TOWN OF
BRECKENRIDGE

Planning Commission Meeting Agenda

Tuesday, December 4, 2018, 5:30 PM

PROPOSED DRIVE PLAN

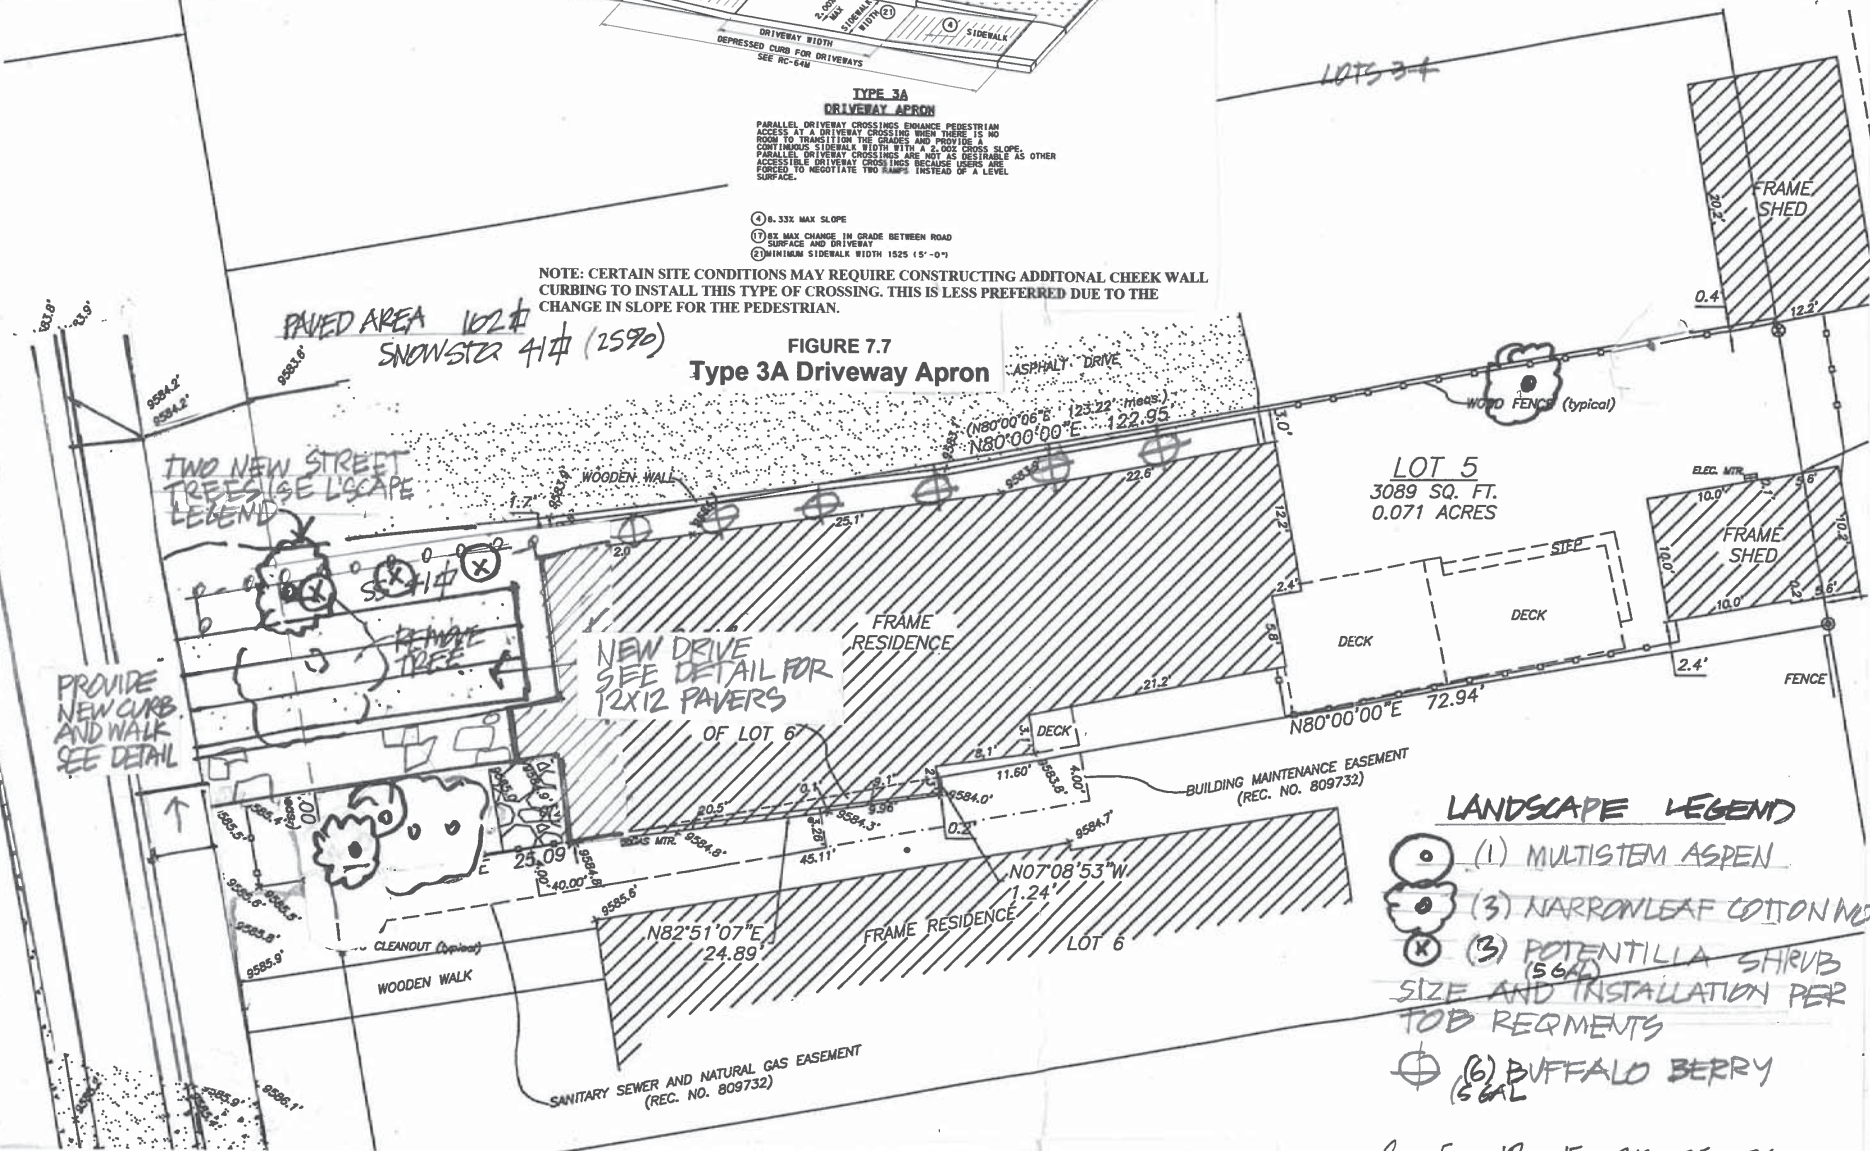
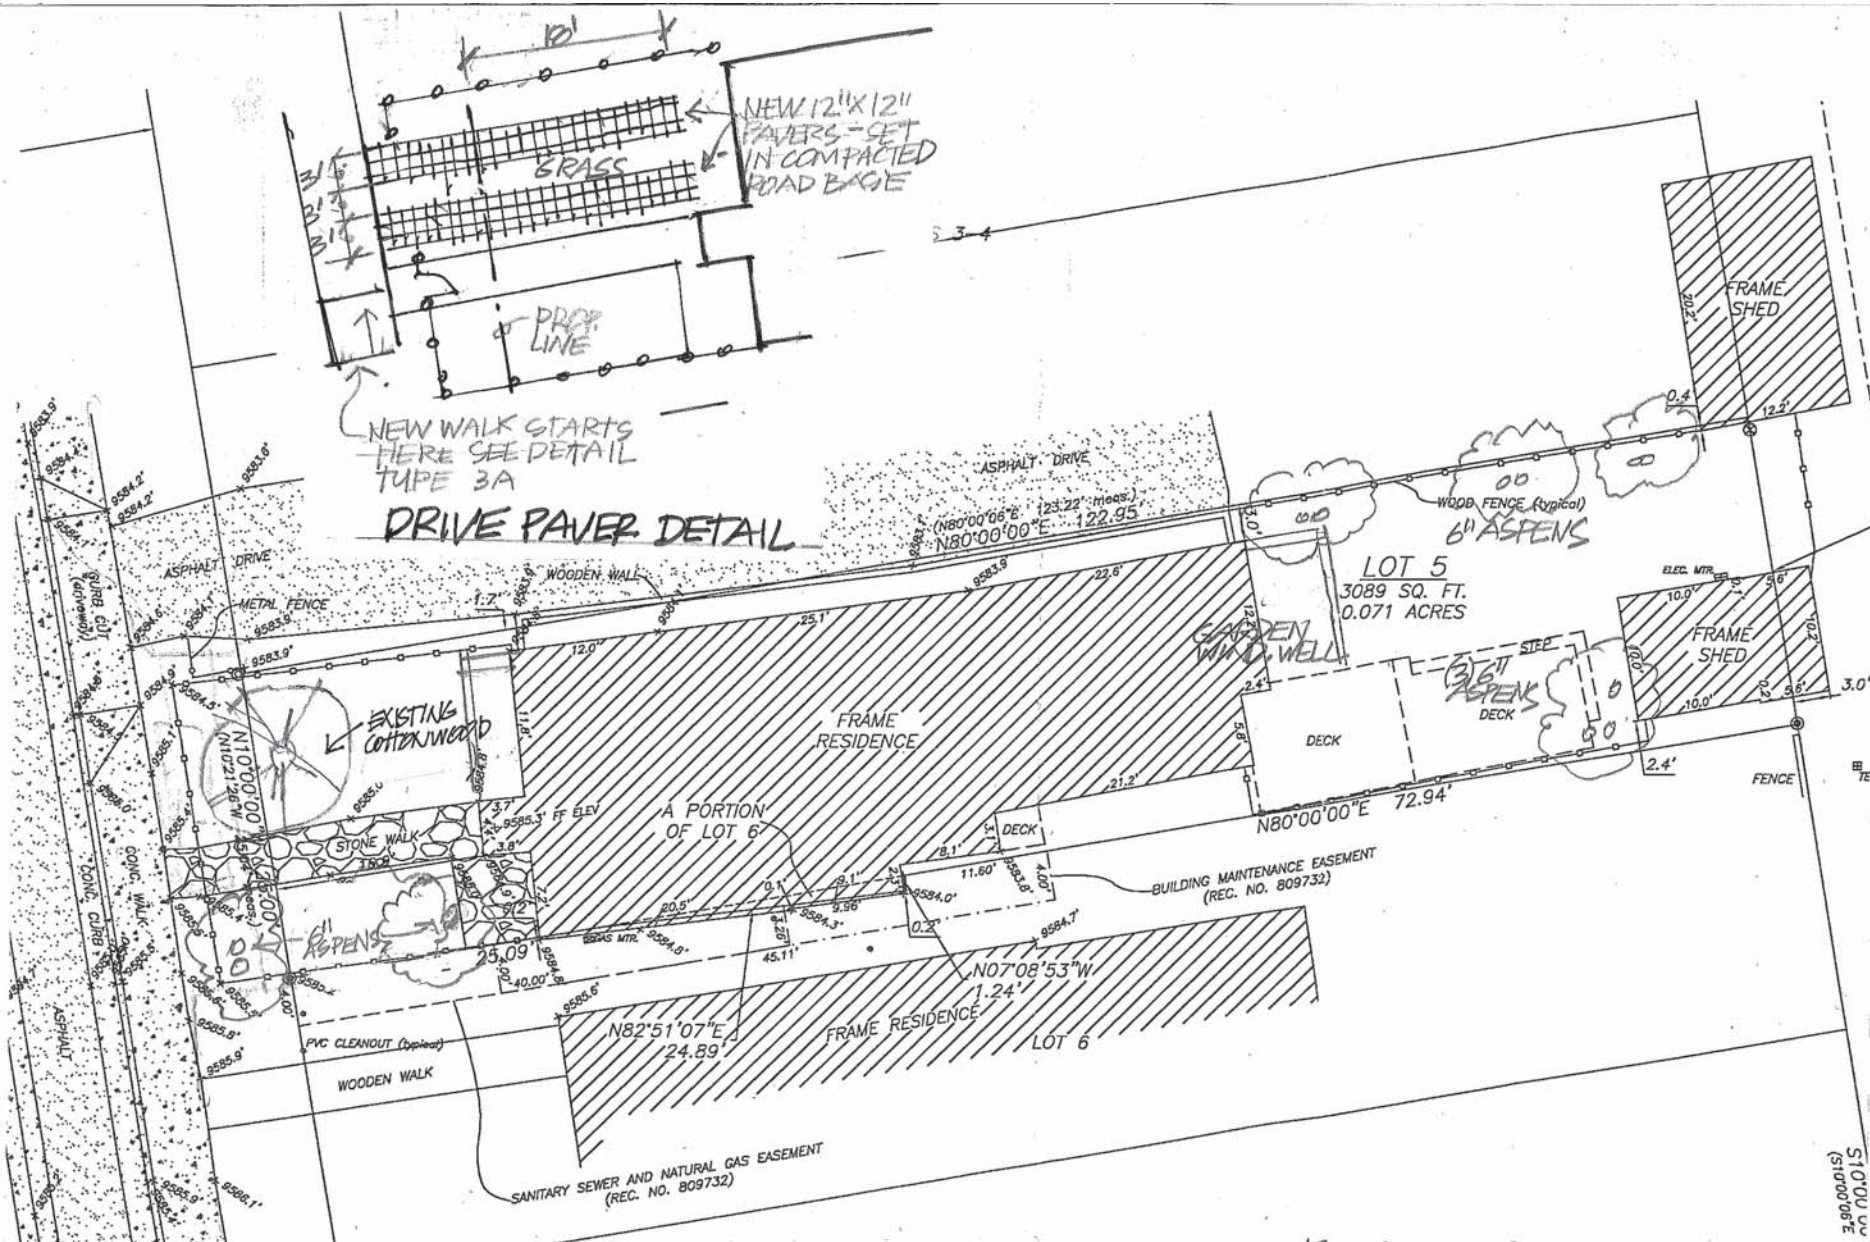
Plant Material & Landscaping (22/A & 22/R): To offset negative points from the driveway installation the applicant is proposing adding landscaping to the property. Existing landscaping includes a total of six significant 6” caliper aspens all of which are proposed to remain. There is a large, hazardous Cottonwood tree that will have to be removed for the placement of the pavers. This is the same Cottonwood tree that was approved for removal with a Class D Minor Development Permit in April of 2018.

These plantings are designed to provide an enhanced buffer from the street and neighboring properties to offset the impact of the parking in the front yard. In addition to Policy 22/R, landscape design is reviewed in the Handbook of Design Standards.

The proposed landscape plan meets the requirement of “*at least one tree a minimum of eight feet (8') in height, or three inch (3) caliper, should be planted at least every fifteen feet (15') along all public rights of way adjacent to the property to be developed.*” While no evergreen tree is proposed to meet Design Standard 131, it may not be feasible to place an evergreen in the front yard due to space constraints. With Cottonwood trees in the front yard to define the street edge, the design complies with Design Standard 132. With the shrubs on the northern side of the proposed paver strips, this design is also compliant with Design Standard 133.

1 BUILDING A - LEVEL 1
1/8" = 1'-0"

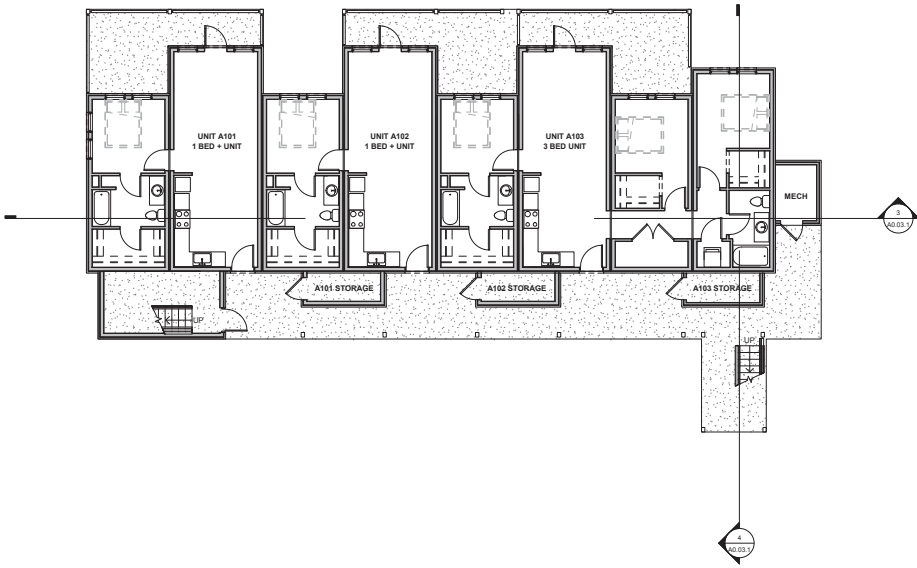
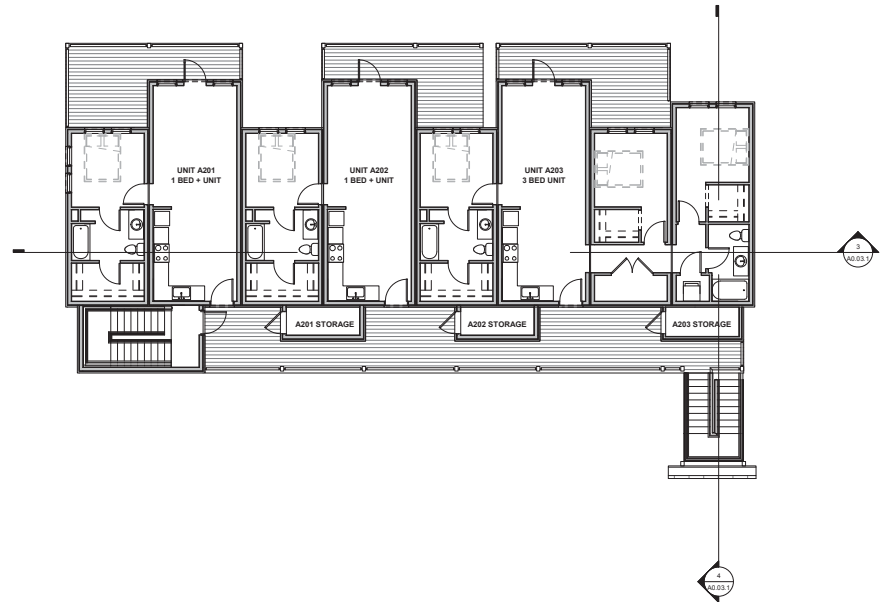
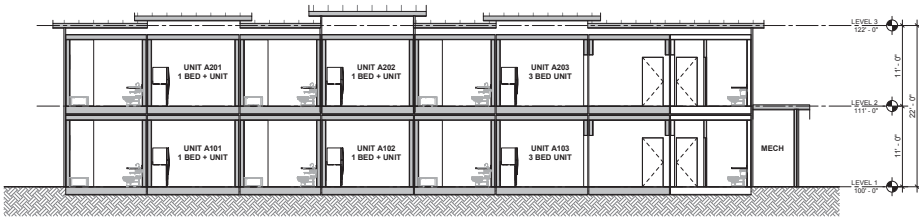
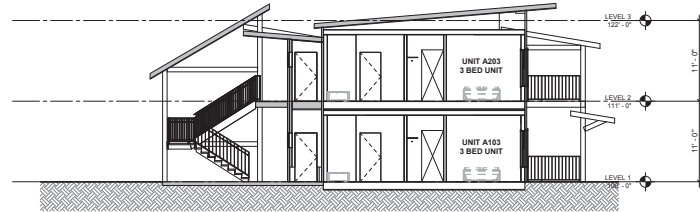
This building is similar to Building A. There is articulation in the façade, vertically oriented windows, and pedestrian scaled entrances along Flora Dora Drive. Staff would like to see some additional windows added to the rear façade.

DEMOLITION PLAN
2

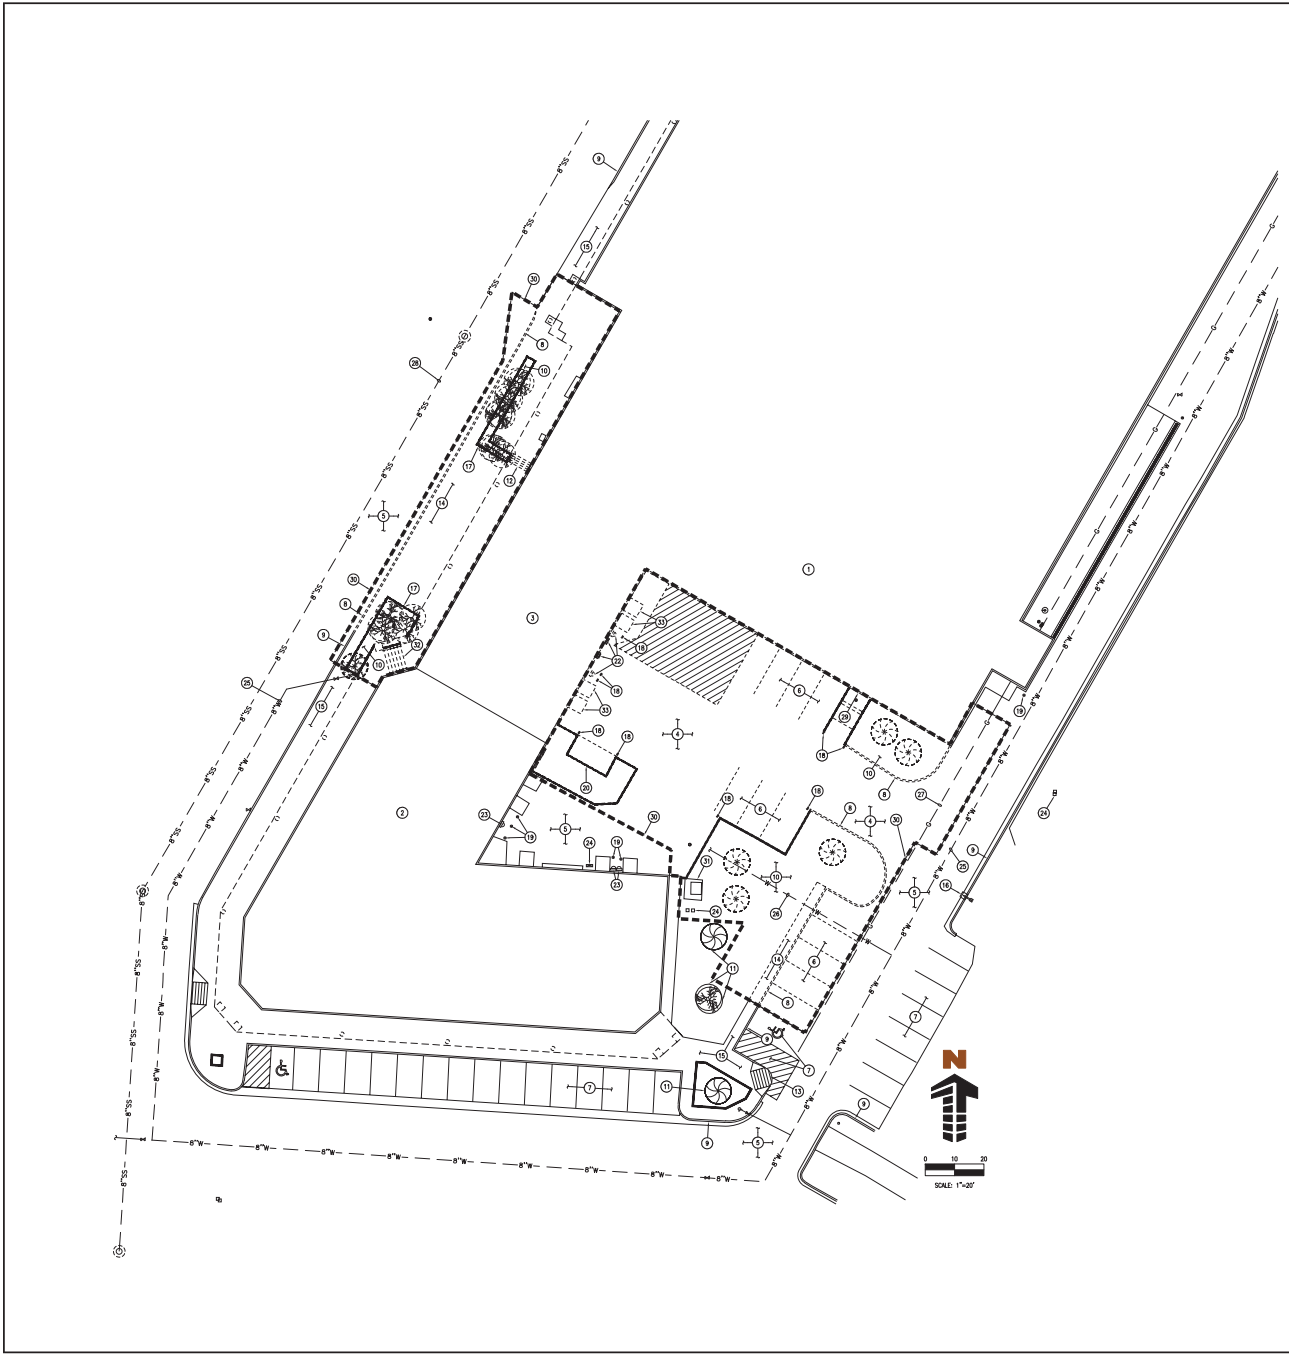
Landscaping (Policy 22/A & 22/R): The Demolition Plan shows approximately ten (10) existing Aspen trees to be removed, as well as the raised timber planters that contain them, to the south of the supermarket's front entry. The applicant has expressed that the removal of the trees is necessary to widen the sidewalk in front of the supermarket and to increase pedestrian safety. The Demolition Plan also shows eight (8) of the eleven (11) trees in the rear (east side) of the building to be removed, leaving two (2) evergreen trees and (1) deciduous tree. The proposed Landscaping Plan shows four (4) Aspen trees and 163 shrubs at the rear of the building. There is not any plant material specified in the front of the supermarket to replace the Aspen trees to be removed. The original 1985 Development Permit for the development of the City Market property received positive four (+4) points for the proposed landscaping, and the property owner entered into a Restrictive Covenant and Agreement with the Town in 1995 to maintain the landscaping installed with the original development.

Because the existing eight (8) trees that are proposed to be removed at the rear of the building are evergreen and provide screening between the supermarket “back of house” operations and the recreation path and Highway 9 to the east, staff believes eight (8) evergreen trees should be added to the proposed Landscaping Plan along the eastern property line to effectively screen the proposed development. Also, the Landscaping Plan should specify quantity and size of proposed landscaping in the legend. Does the Commission agree that the landscaping quantities at the front and rear of the supermarket are required to be maintained?
